DRAIN PUMP BLOCKAGES

DESCRIPTION:

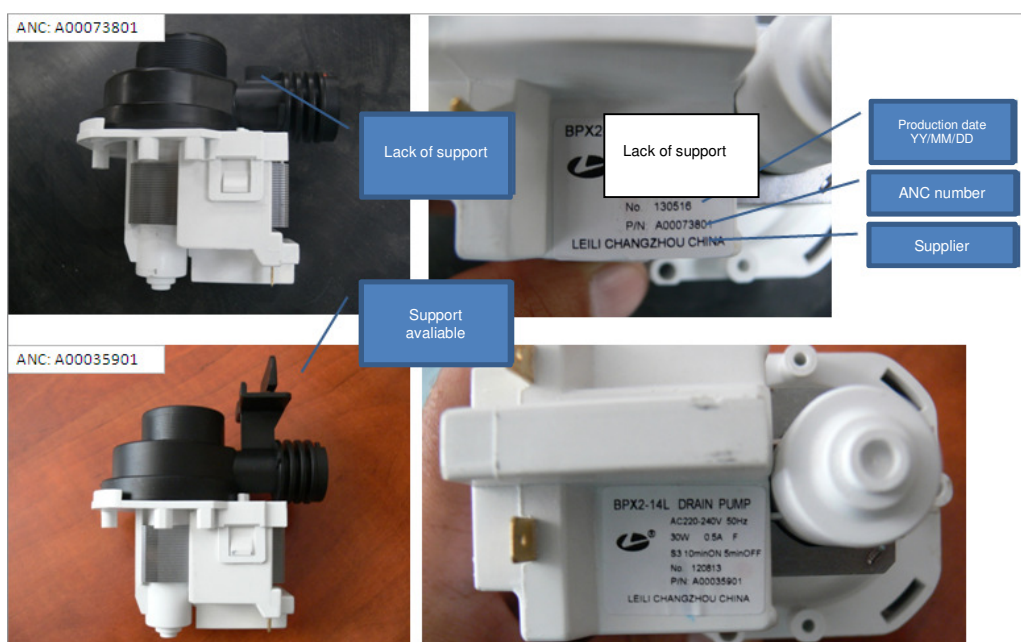
It is possible for drain pumps from manufacturer Leili produced before 24.05.2013 to become jammed.

1. Identify the drain pump you have by comparing the data label with those below.
 The later pumps also have a support bracket.

2. Replace with a new one produced after 24.05.2013.

Do not unblock the pump, replace with a new one!
 Specific part numbers can be located on TDS for the model you have.
